Crown Sydney Hotel Resort Modification

*State Significant
Development
Modification Assessment
(SSD 6957 MOD 1)*

October 2019

Figure 6 | Level 3 Restaurant Terrace - approved (left) and proposed (right) (Base source: EIS)

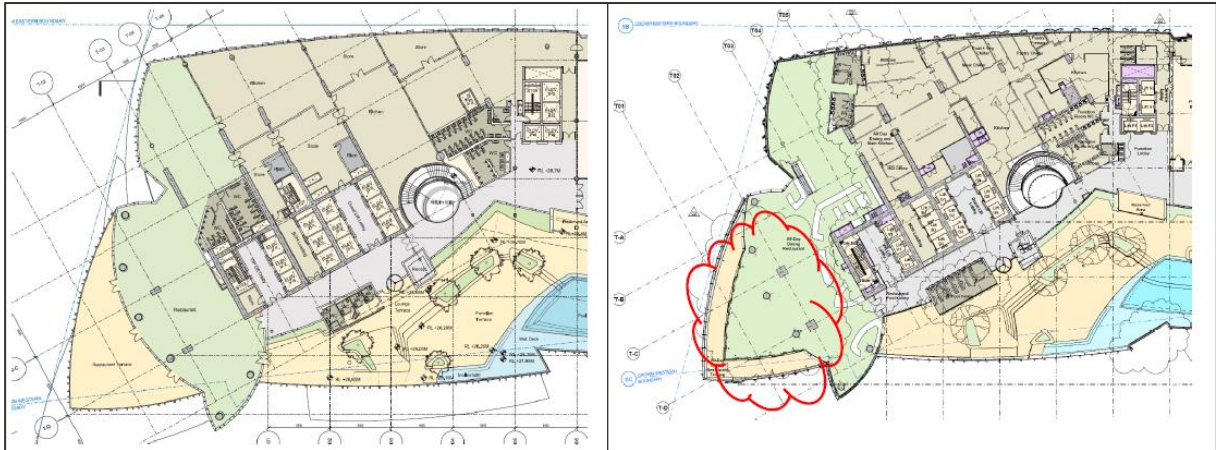
The modification seeks to partially enclose the north-western terrace associated with the restaurant on Level 3 (**Figure 6**). This involves the relocation of the exterior glass wall of the restaurant to enclose a greater portion of the exterior terrace which results in a proposed change from outdoor to indoor use.

The new enclosed areas will not result in any substantive adjustments to the building design or shape as approved under the SSD Approval as the exterior glass over sail and stone veil, which is the primary building façade in this location remains unchanged. As such, the Department considers that the proposed modification to the terrace areas will result in substantially the same development as that originally approved and would not give rise to visual or amenity impacts.

Figure 8 | Proposed public viewing deck on Level 66 (left) and proposed change to the eastern elevation (right)
(Base source: EIS)

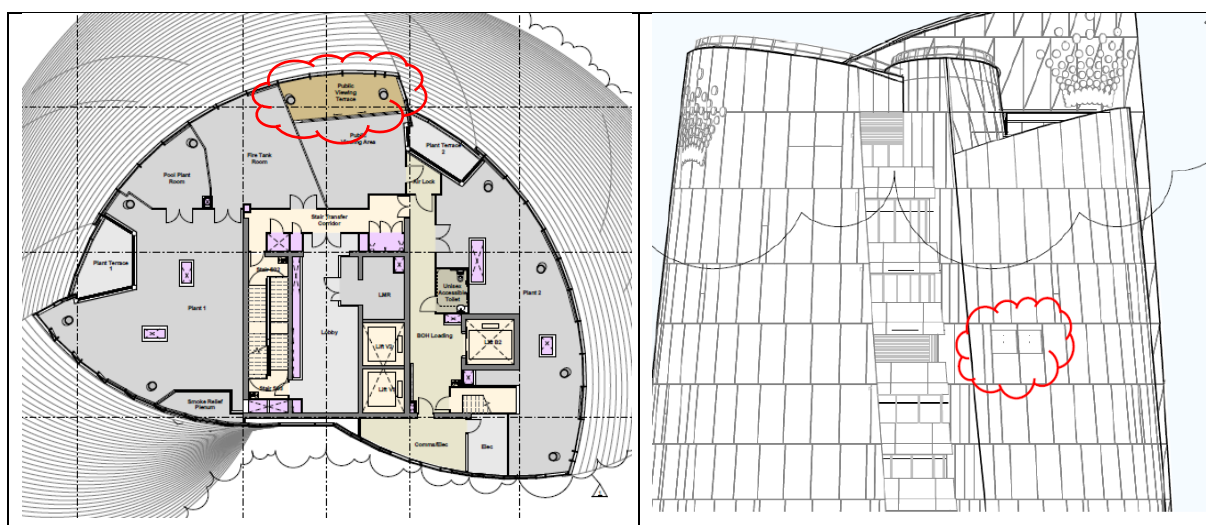
The modification seeks the inclusion of an observation deck on the eastern side of Level 66 (**Figure 8**). The observation deck will be publicly accessible and allow for views over the Sydney Harbour.

The Department considers the modification acceptable as it will remain largely unnoticed when viewed from the public domain, due to its location within the building on Level 66 which is approximately 250m above ground level. The amendment also responds to Condition B6 of Development Consent SSD 6957, which requires the provision of a public accessible observation deck within the building.

The Department notes the observation deck does not extensively change the appearance or massing of the building and the modification is negligible in the context of the overall development.

Figure 9 | Approved Level 51 layout consisting of two residential apartments (left) and proposed Level 51 layout consisting of 3 residential apartments (right) (Base source: EIS)

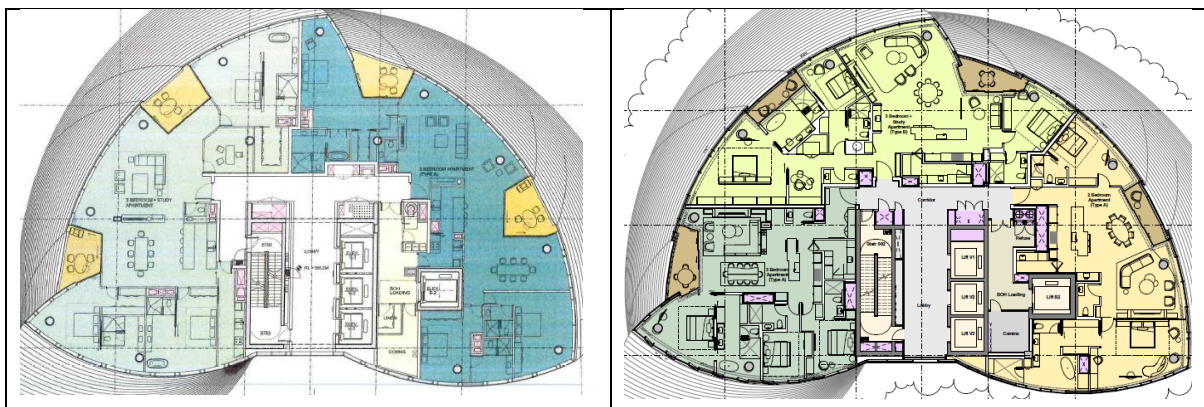
An example of the proposed modified layout is provided in **Figure 9** below.

In its assessment of the SSD Approval, the Department considered the proposal provided an acceptable level of amenity. The Applicant has submitted a Design Verification Statement confirming the modifications are consistent with the design quality principles and objectives of the ADG.

Figure 10 | Proposed residential apartment layouts containing internal study rooms (Base source: EIS)

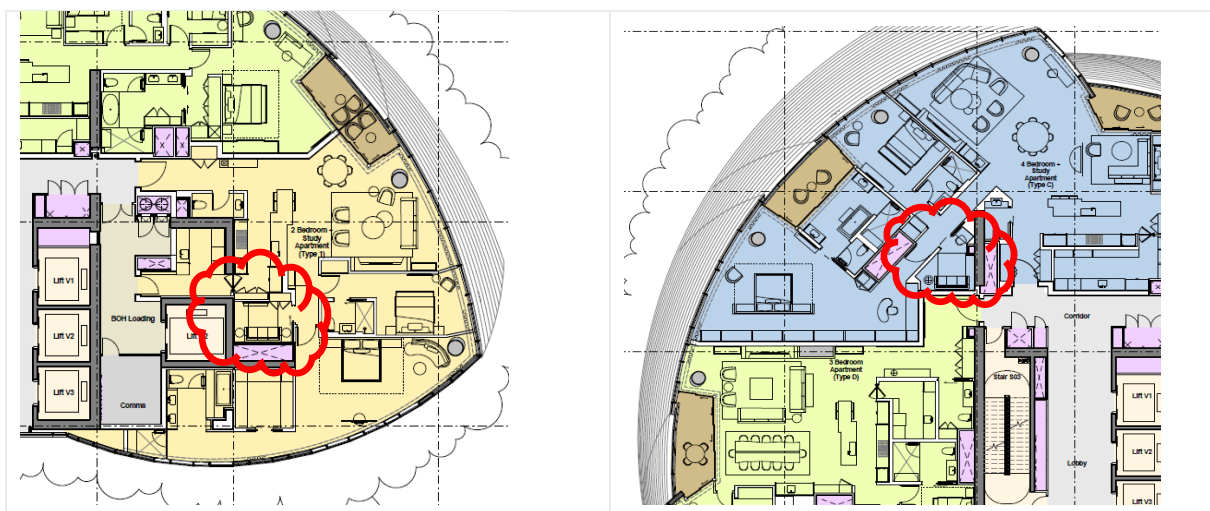
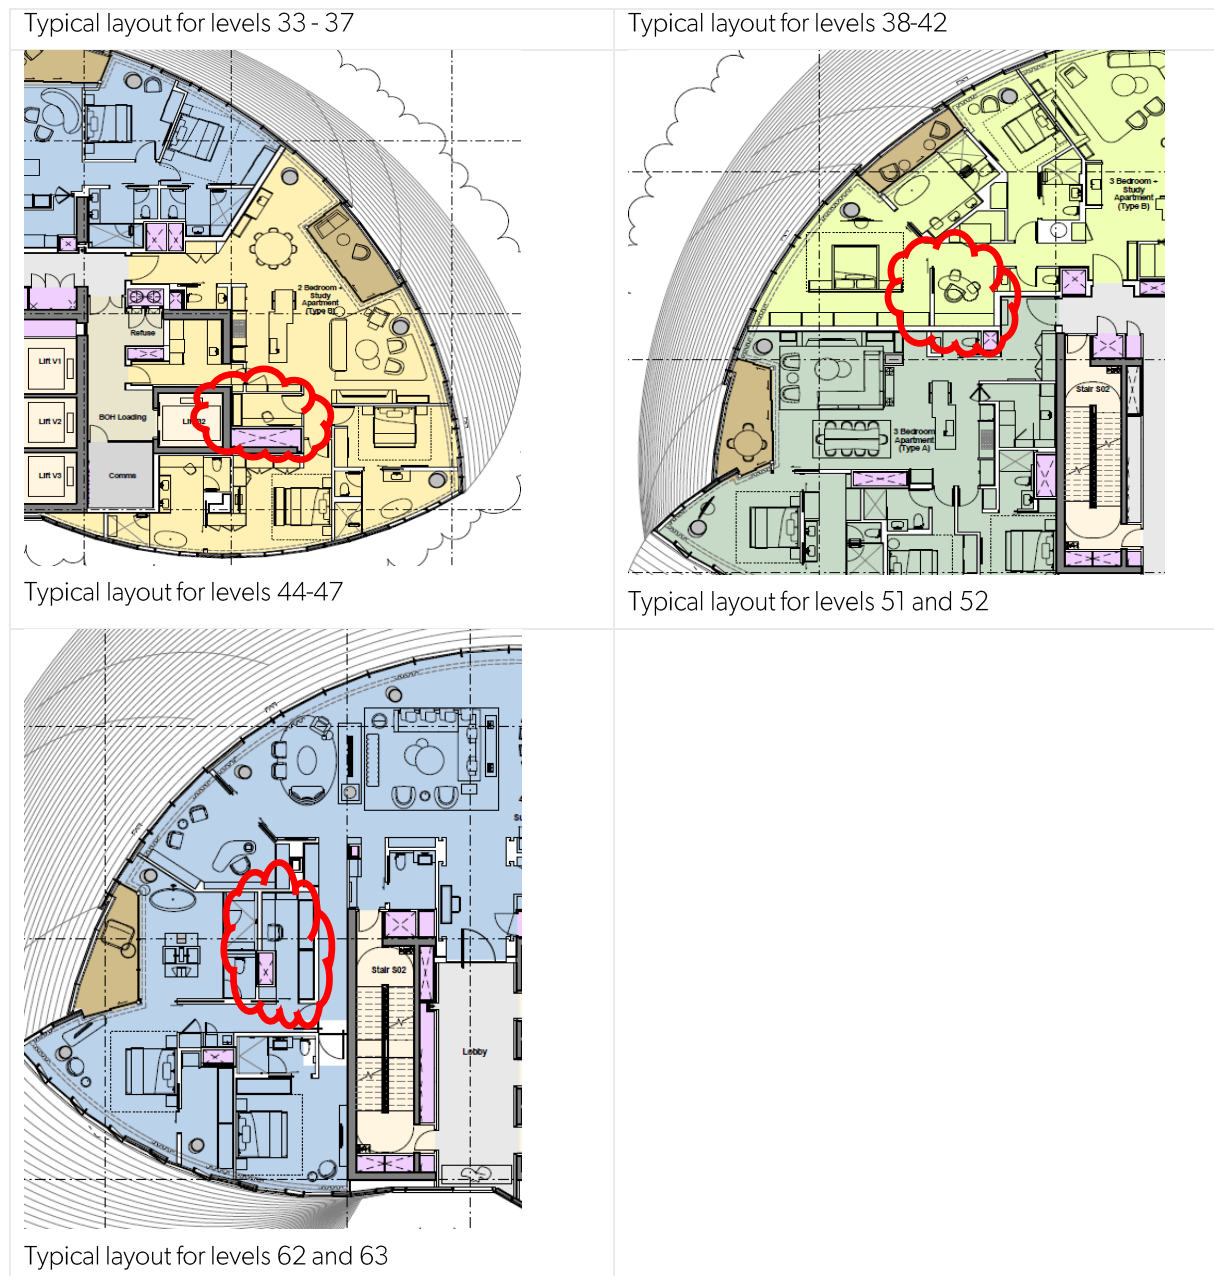
The ADG recommends all habitable rooms be provided with an external window. The proposed reconfiguration to internal layouts includes 22 residential apartments with studies/media rooms that are not provided with an external window (**Figure 10**). This equates to approximately 25% of the total residential units.

The Applicant considers the proposed layout achieve the intent of the ADG as the studies are designed to utilise borrowed light from an adjoining room and will be mechanically ventilated. While this arrangement is not consistent with the ADG design criteria, the overall objective of this section of the ADG is to ensure the layout of units are functional, provide a high level of amenity, maximise environmental performance and accommodate a variety of household activities and needs.

The Department particularly notes the size of the units significantly exceed the minimum ADG recommendation and the layout of the units are well designed to provide open plan, flexible living arrangements, As such, the Department considers the proposed study provision acceptable as future occupants of these units will receive a high level of amenity.
